FINAL DRAINAGE REPORT

PIKE SOLAR PLUS STORAGE PROJECT

EL PASO COUNTY, COLORADO

Engineering Review

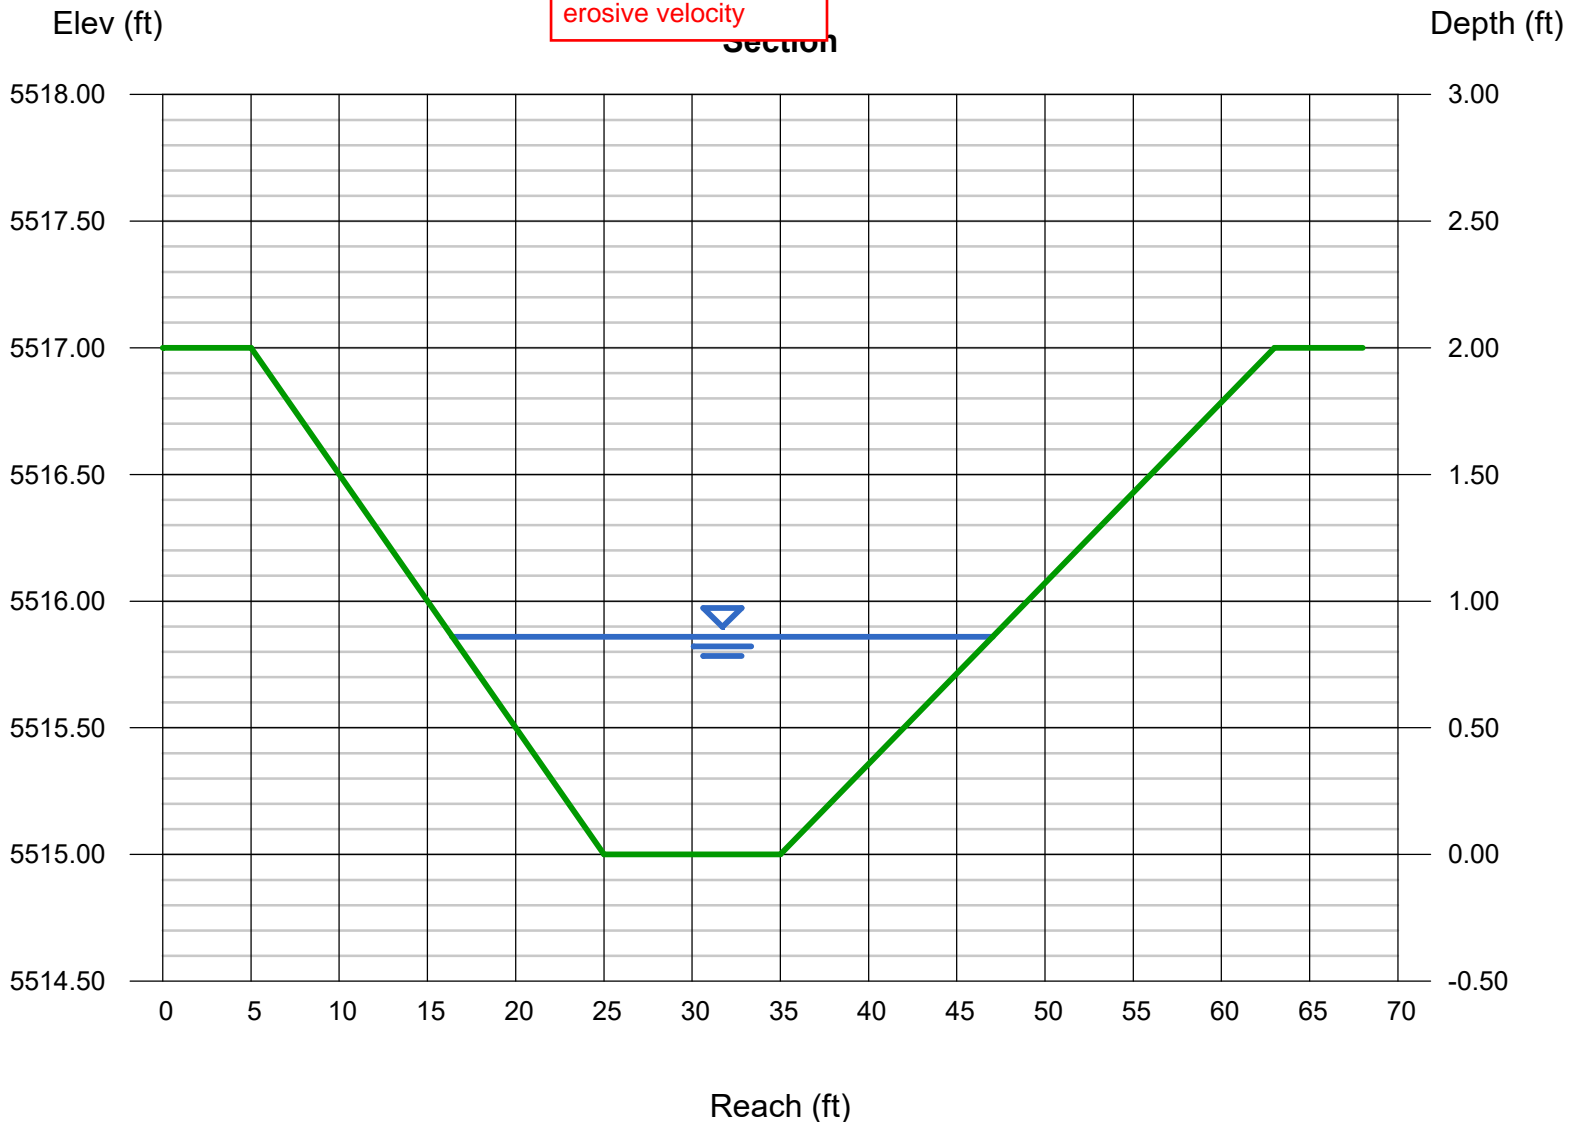
Add a note specifying
lining type for the
supercritical flow.

FLOODPLAIN CROSSING #1

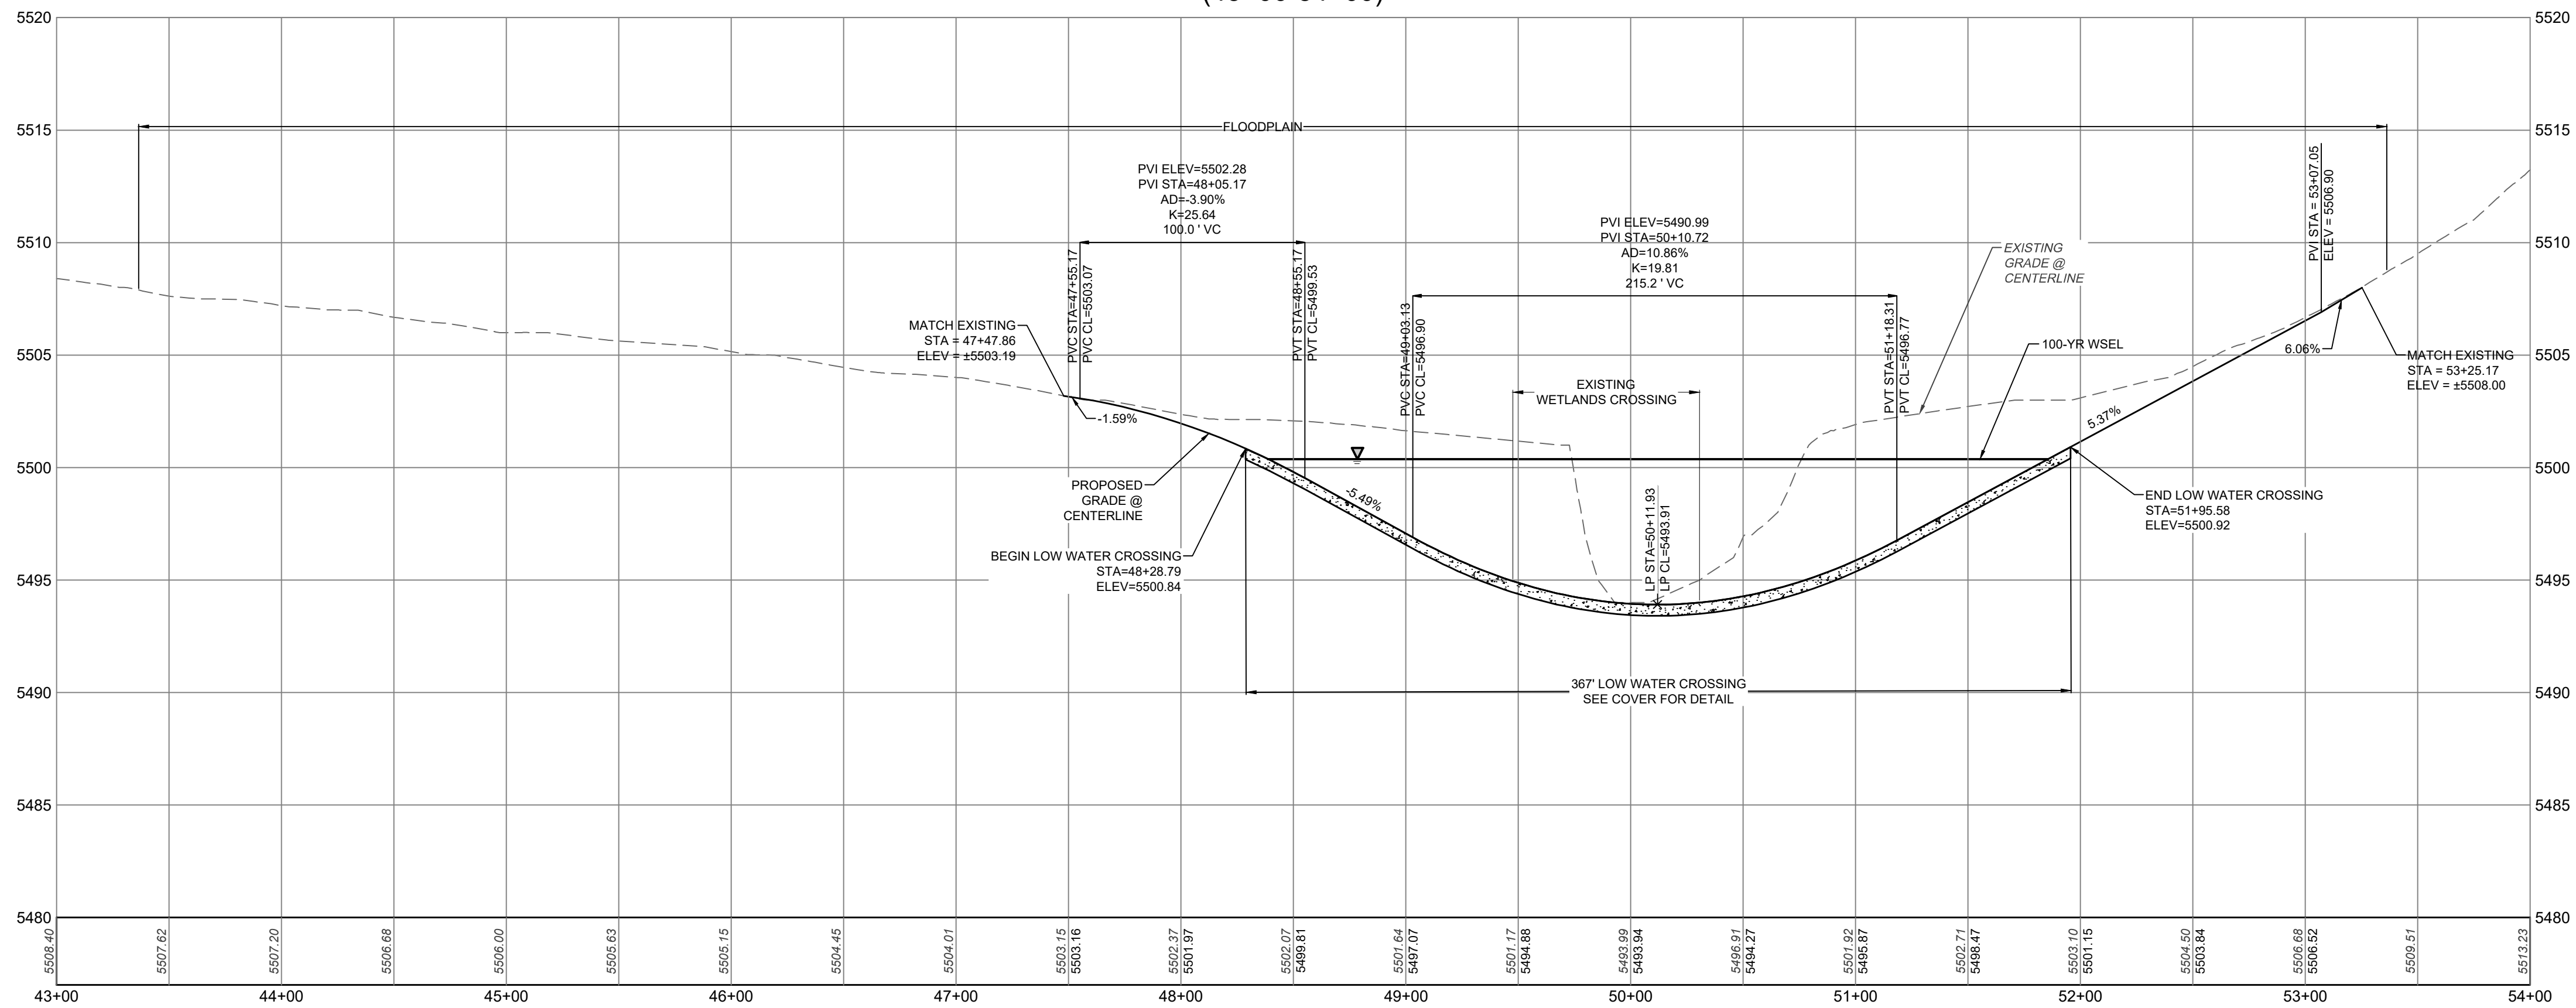
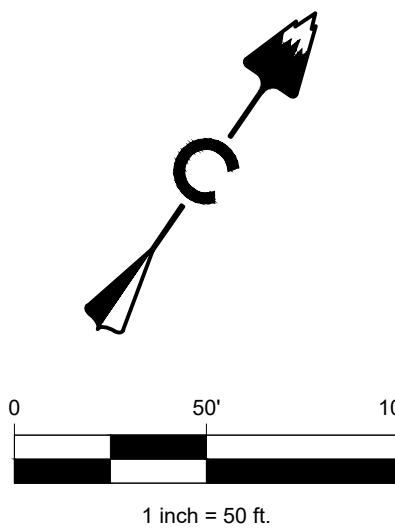
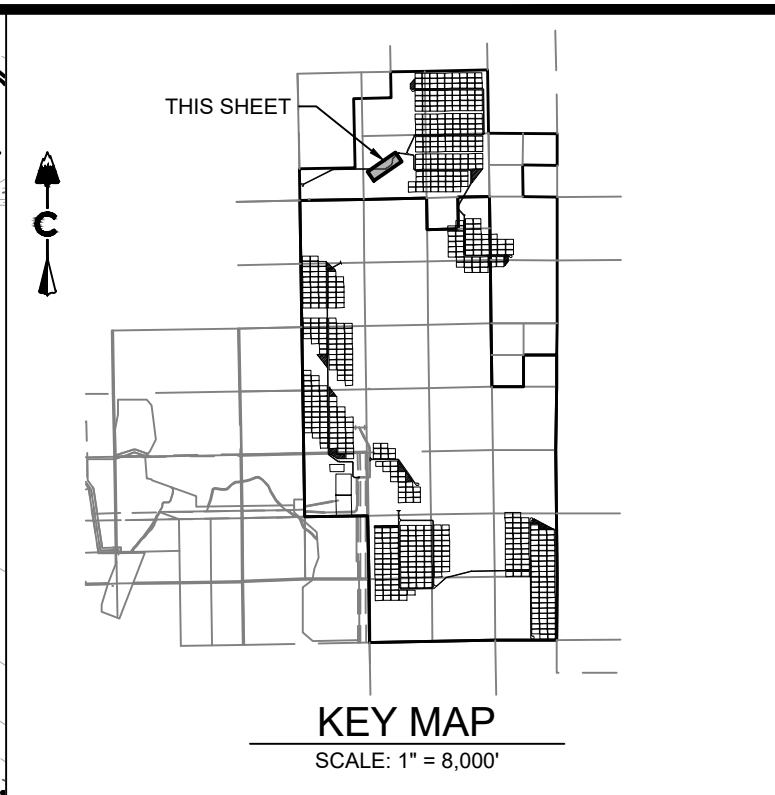
Label proposed material

Added, section is on cover as well

ECB added at 4:1 slopes and riprap swale added for roadway and for crossing
